**WOODS CROSS CITY
PLANNING COMMISSION AGENDA
TUESDAY, JUNE 23, 2026, AT 6:30 P.M.**

STAFF REPORT

Re: Amended Site Plan Review – EV Auto

Location: 612 West 800 South

PLANT SCHEDULE EV AUTO ADDITIONS 2026 05 11

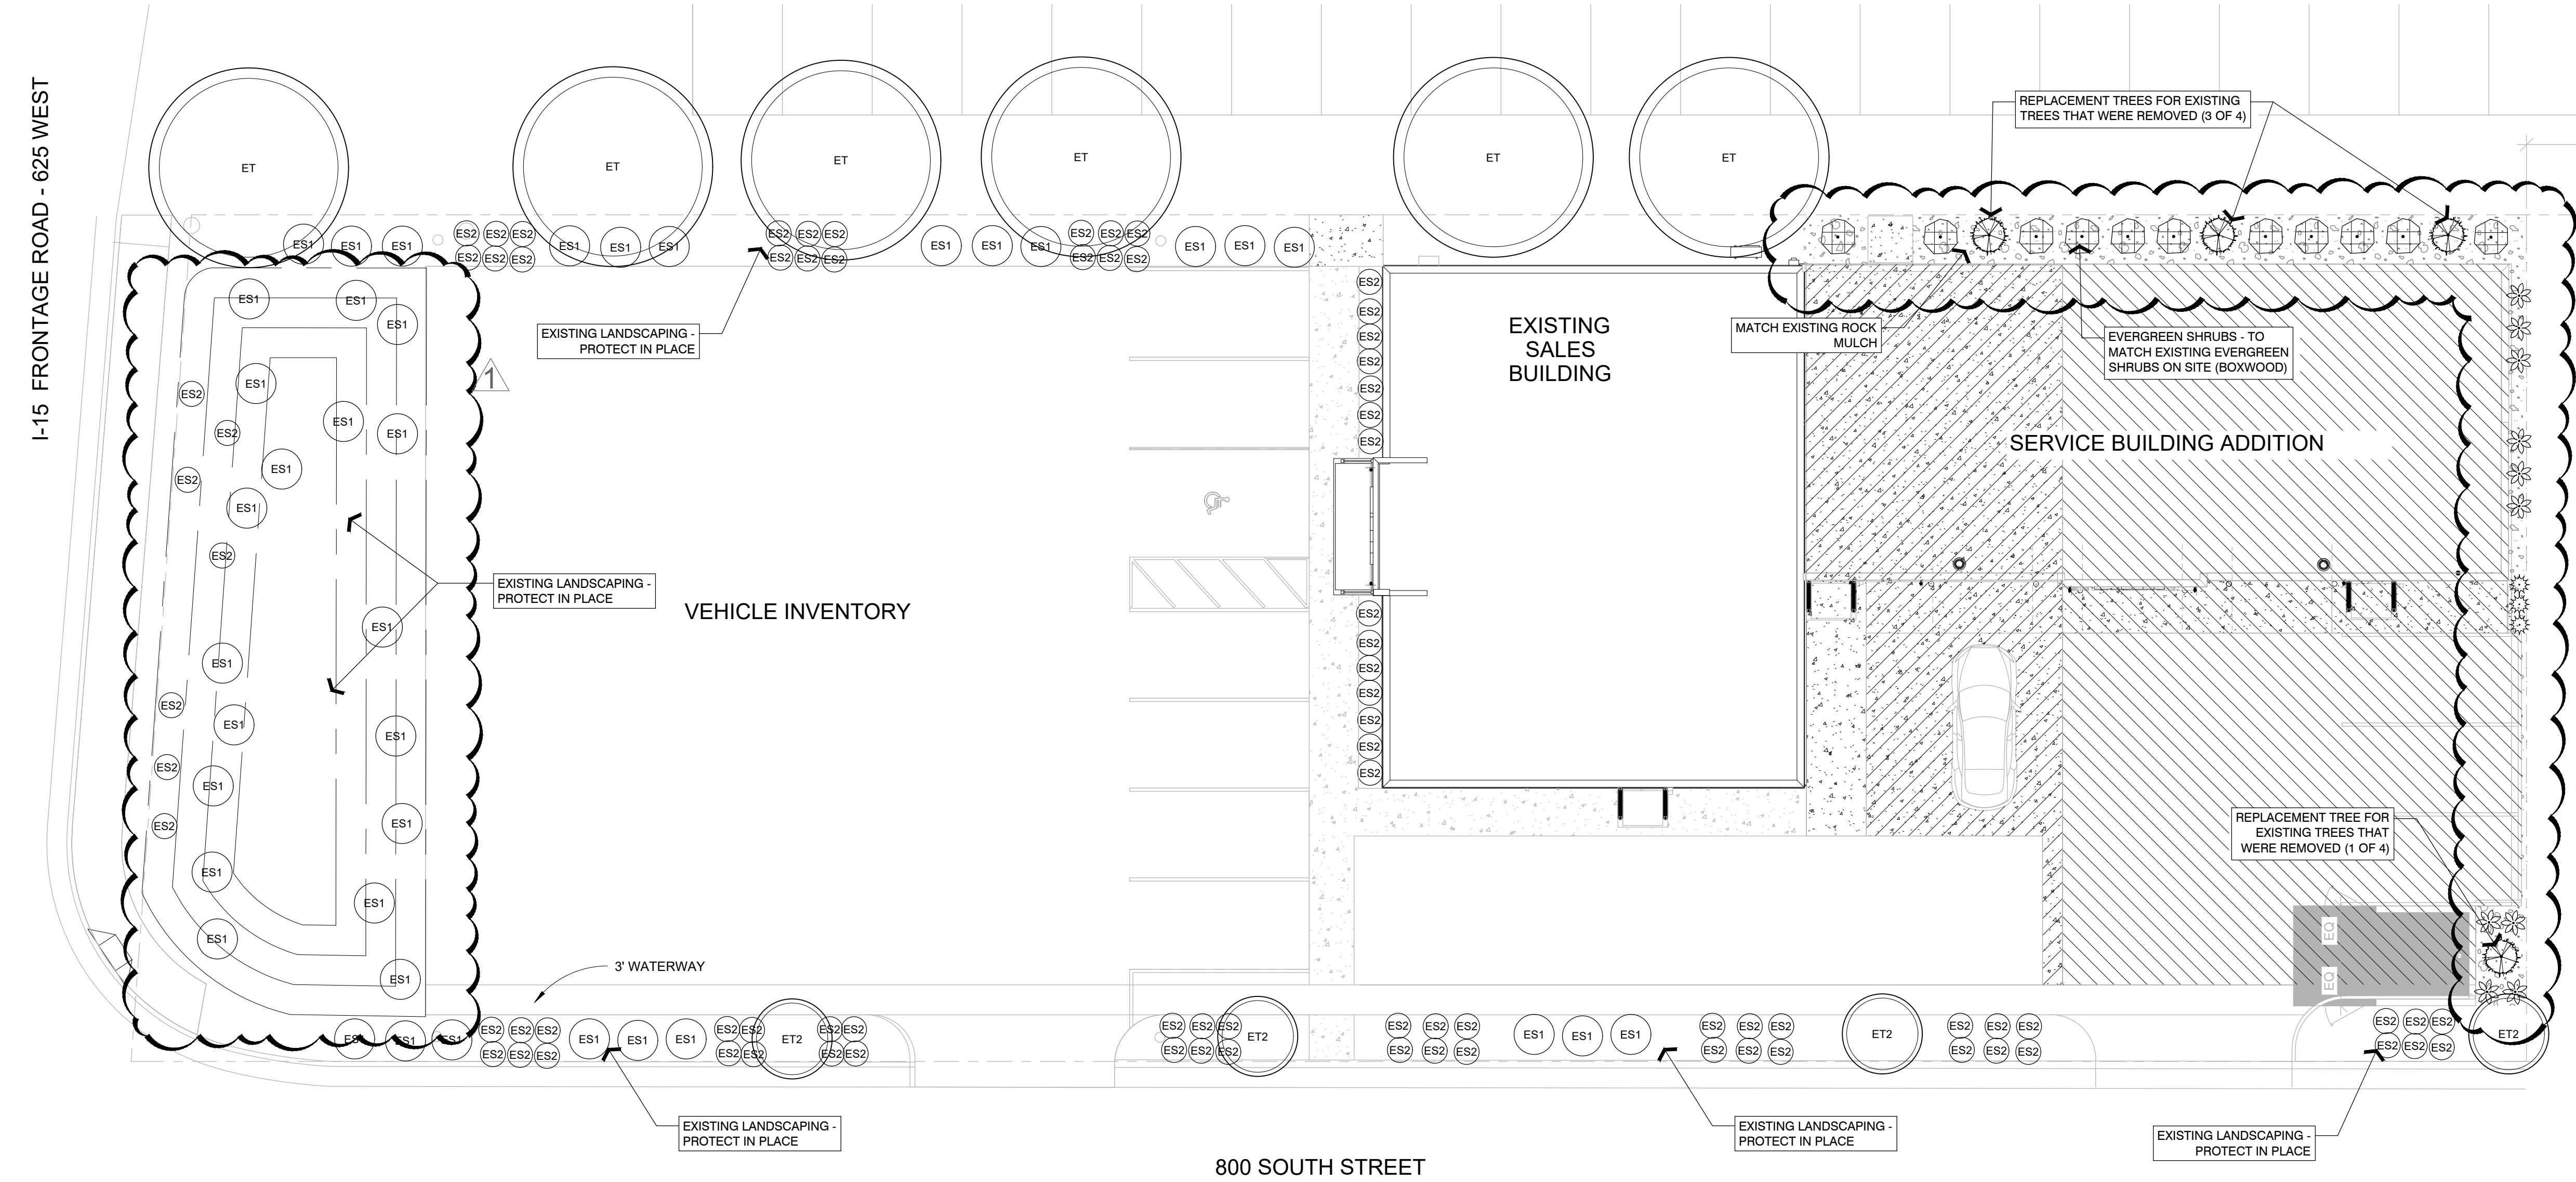
The landscape plan includes replacement trees for existing trees removed during construction, additional evergreen trees, shrubs, ornamental grasses, and rock mulch landscape beds. Existing landscaping along portions of the site perimeter will be preserved. The submitted landscape plan

demonstrates compliance with the City's landscaping requirements and provides screening and aesthetic enhancements for the development.

SHEET TITLE
ELEVATIONS

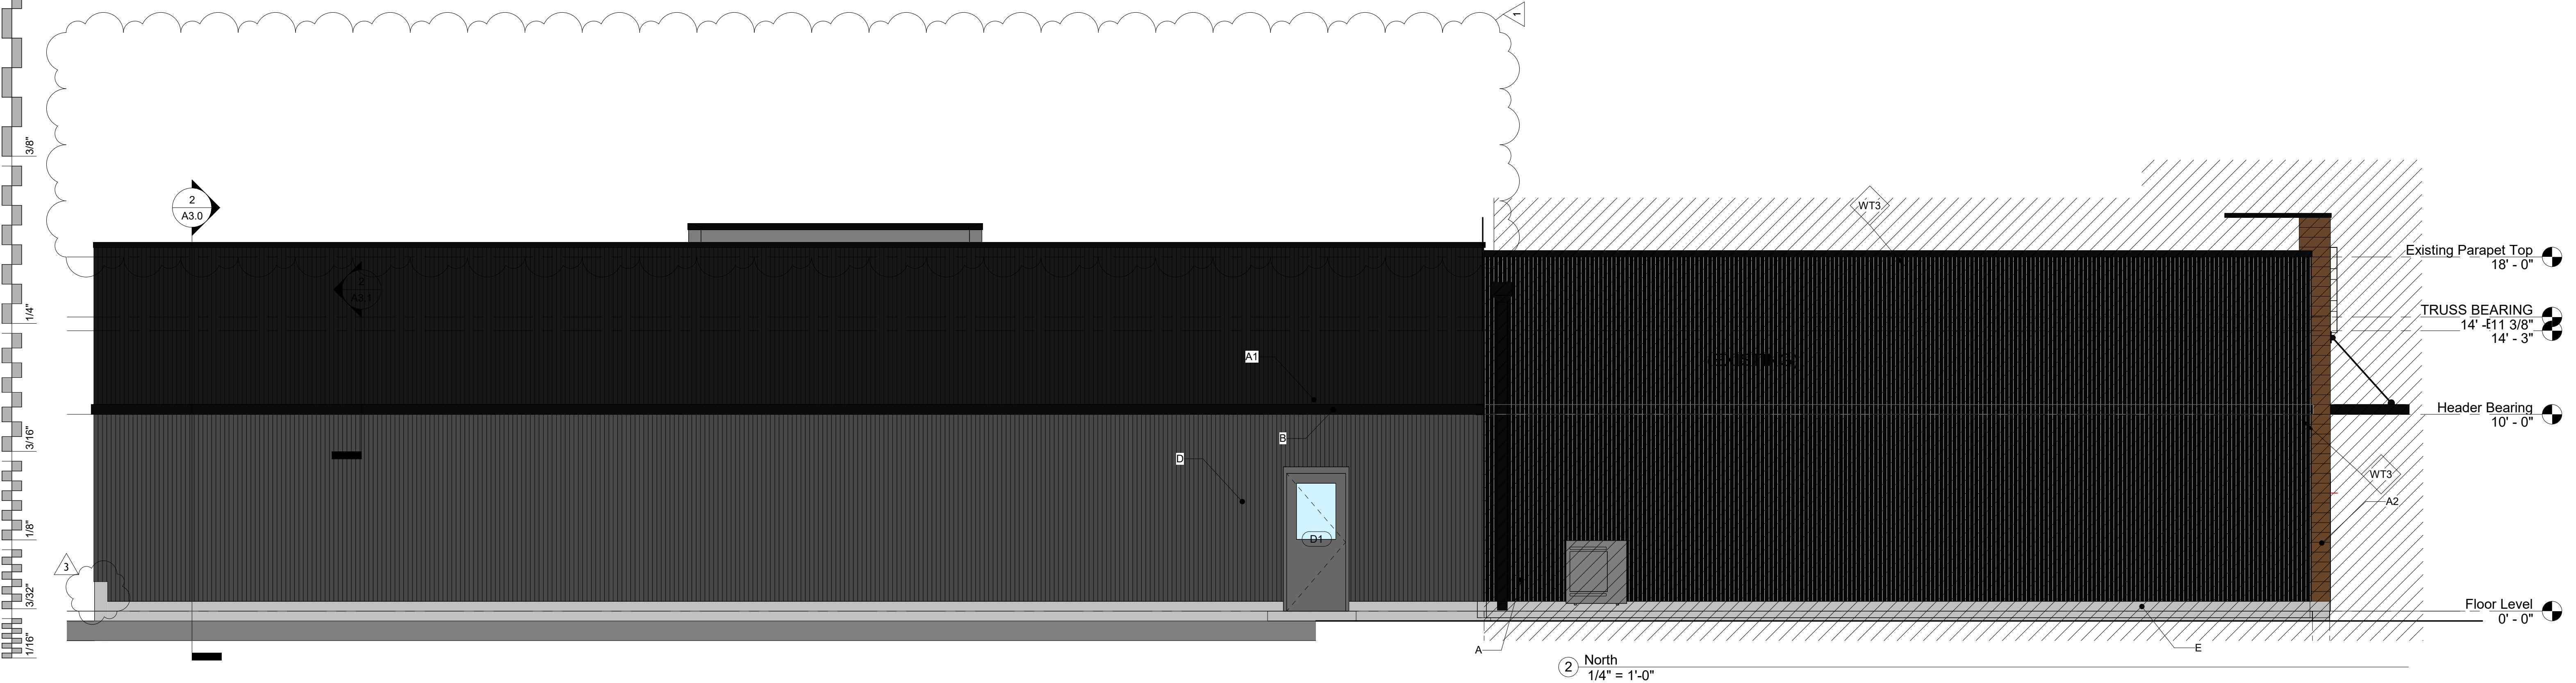
The building elevations show a contemporary commercial design utilizing metal wall panel systems with a combination of matte midnight black and ash gray finishes, accented by dark antique oak architectural panels at the primary entrance feature. The façade incorporates varying wall planes, overhead service doors, storefront glazing, and enhanced entrance detailing that creates visual interest and complements the existing dealership building. Staff finds the proposed architectural design consistent with the design standards found in code.

PHOTOMETRIC SITE PLAN

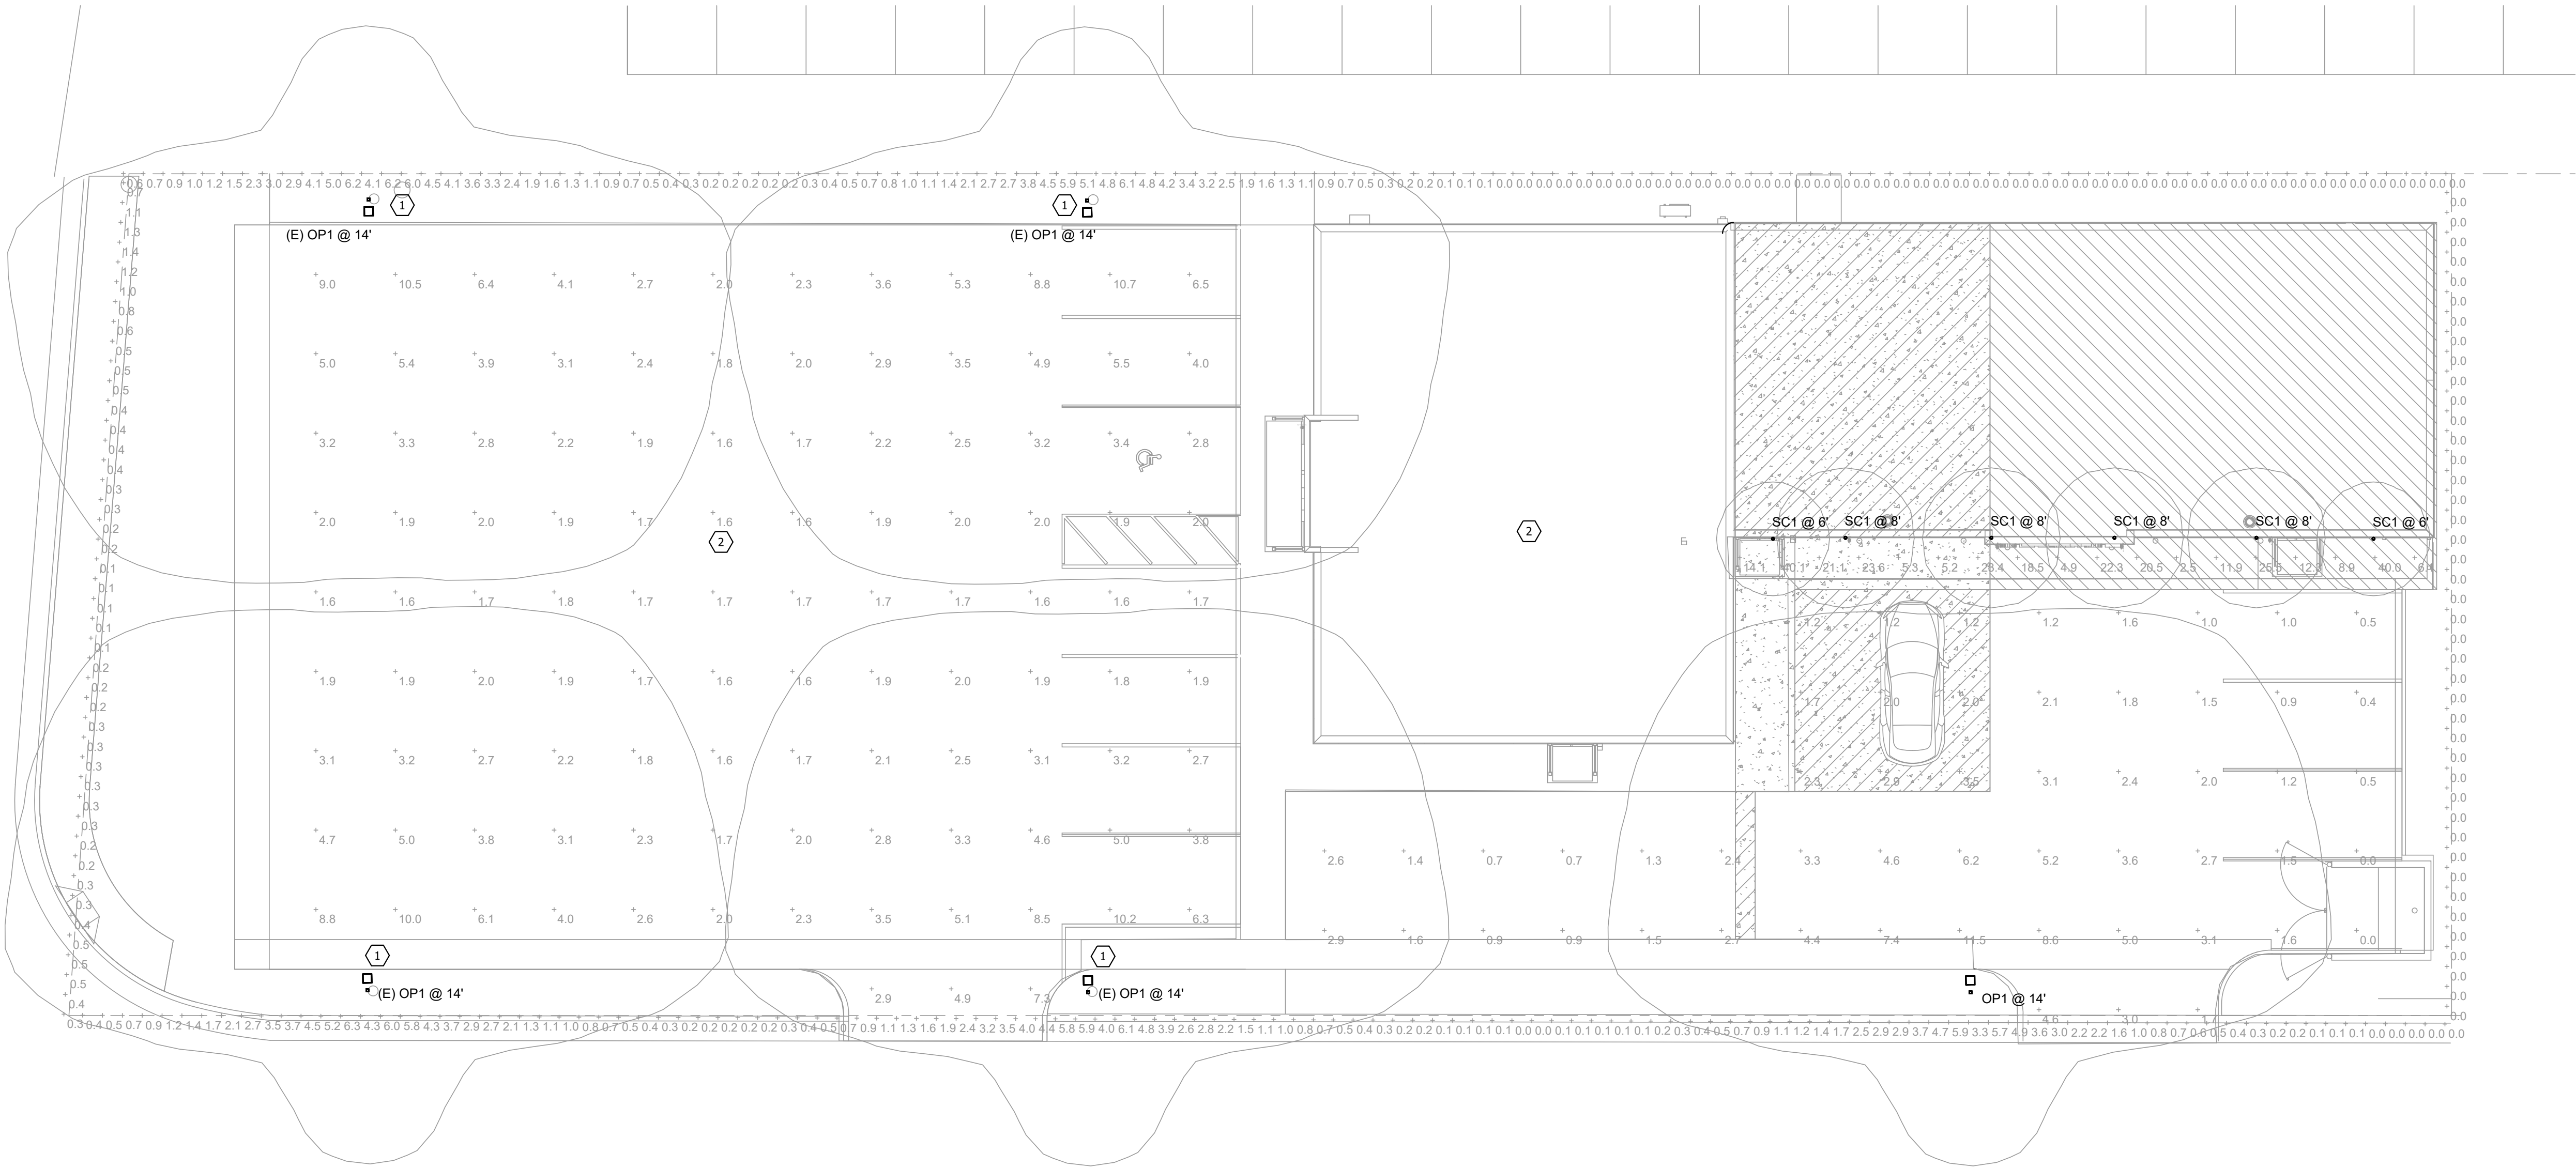
The photometric plan indicates lighting levels at the property boundaries exceed what is permitted by code. The light readings must be zero at the property lines. The applicant will need to prove this will be met prior to receiving a building permit.

1. Provide the City with an approval certificate from South Davis Metro Fire and inspection reports during construction phases.
2. Provide a photometric plan that complies with city standards prior to receiving a building permit.
3. Resolve all issues with the City Engineer prior to receiving a building permit.
4. Obtain a building permit.
5. All site improvements, landscaping, drainage, parking, and utility improvements shall be installed in substantial conformance with the approved amended site plan.
